4464 Dunbar Street (COMPLETE APPLICATION)
DP-2018-00363 – C-2

DEVELOPMENT PERMIT STAFF COMMITTEE MEMBERS

EXECUTIVE SUMMARY

DEVELOPMENT PERMIT STAFF COMMITTEE RECOMMENDATION: APPROVE

Figure 2. Section A

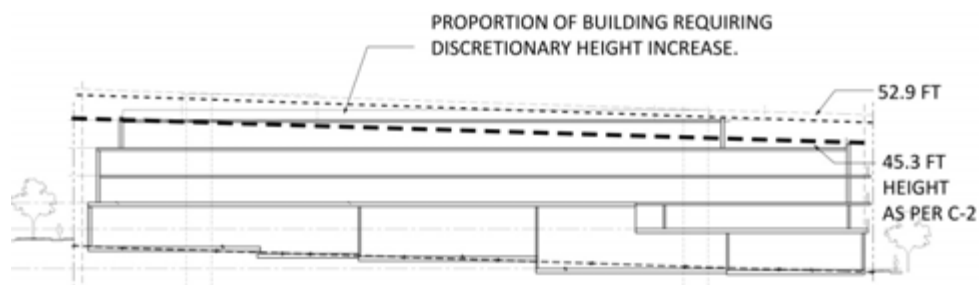
The application conforms to 45.3 ft. building height at the north and south end of the building with a 4 storey massing. The middle portion of the building projects the permissible building height and contains 5 storeys (see Figure 2). In addition to the uppermost height, some building portions at rear project through the permissible height envelope, including projections on the fifth floor and increases of the extent of 10.7 m (35 ft.) height at the south and north end of the building (See Figures 3).

Staff consider these discretionary increases of height based on the zoning and design guidelines. The site takes a full block with an exceptionally large frontage of 85.25 m (279.69 ft.). It has significant slope conditions with a slope down south along Dunbar Street by approximately 2.8 m (9.3 ft.) and to Dunbar Street from the lane by approximately 1.6 m (5.4 ft.) creating a cross-slope of 4.5 m (14.7 ft.). The block to the south is developed as a five-storey mixed use building with a discretionary increased building height to approximately 52.9 feet. In the case of this particular context and site condition, staff considers this site merits consideration for additional height provisions of the zoning and guidelines.
